ADDENDUM NO. 1

PROJECT: Adams Pond Restoration Project

RFP NO.: 216-4-1

DATE: June 3, 2026

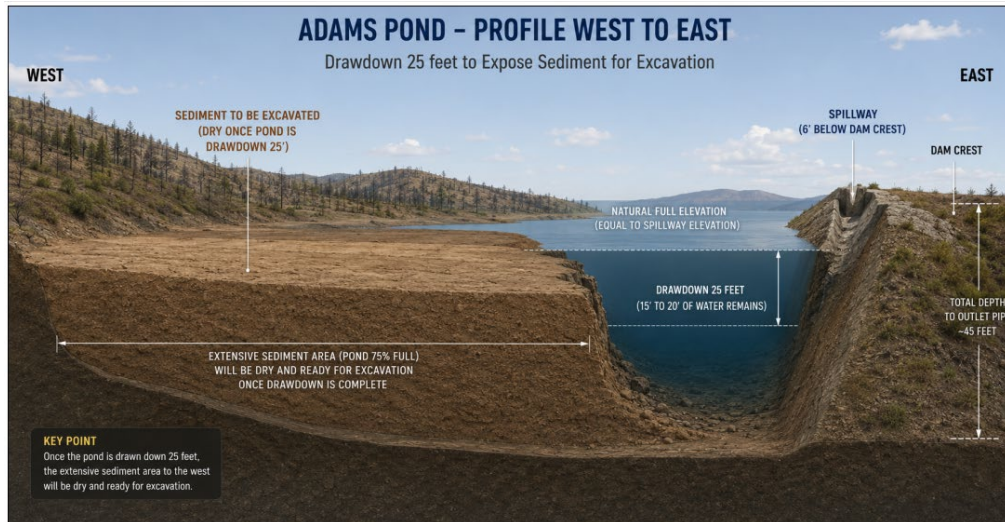
- How deep under water level do we go down? **(SEE FIGURE BELOW)**
 - ❖ The existing pond drain is approximately 45 ft below the spill way. It is anticipated that the pond will be drawn down approximately 25 feet from the pond's existing water level.

- Will there be a berm separating the pond from the new pond bed
 - ❖ See Figure. Recommendation: Once the pond water level has been drawn down, sediment may be removed to an elevation approximately 1 foot above the drawn down pond water level. Maintaining this 1-foot elevation difference between the proposed new pond bed and the drawn-down water level will provide positive drainage and allow any accumulated water or flowing water within the work area to drain back into the pond. This will also allow for the installation of a ditch along the north side of the pond's excavation limits to carry groundwater or flow resulting from rain events to pass through the excavation limits and discharge to the pond. Maintaining the elevation differential will also prevent pond water from backing up into the tile drain/drainage way into the excavation limits.

- ❖ The new pond bottom will be flat as possible. Pond side slopes shall be sloped to ensure bank stability and worker safety.
 - ❖ Contractor may elect to add ditches or sumps throughout the excavation area to accelerate the sediment dewatering.
